## PRODUCT SAFETY NOTICE

### ProTech™ Aluminum Key-Lock Carabiner.

Red auto-lock with keeper, part# **300153**

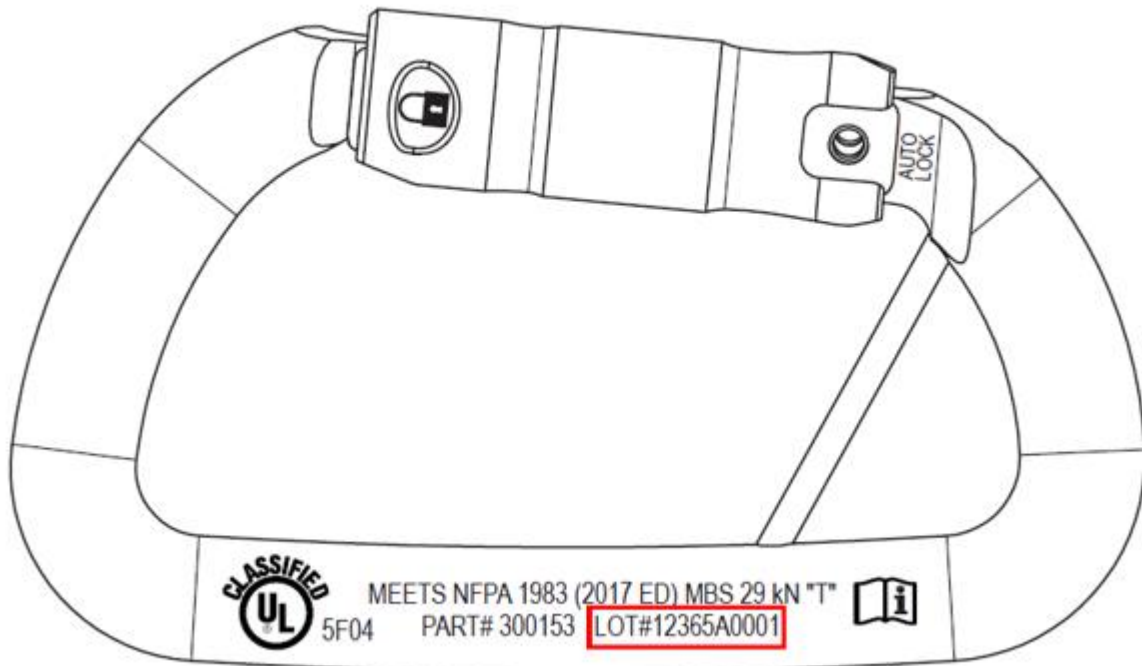
CMC Rescue has become aware of an issue regarding the ProTech™ Aluminum Key-Lock Carabiner. A defect in the manufacturing process resulted in a small population of carabiners having surface cracks that could impact the minimum breaking strength (MBS) of the product. This defect manifests itself as a recessed area, crease, or crack on the upper bend of the carabiner as indicated in the highlighted location below:

CMC requests that you inspect all units and kits having carabiners from the two lot numbers identified for this condition. If you find a carabiner or kit with the condition listed above, please immediately remove the unit from service and contact our customer support team by calling (800) 513-7455 or (805) 562-9120, or via email at [info@cmcrescue.com](mailto:info@cmcrescue.com).
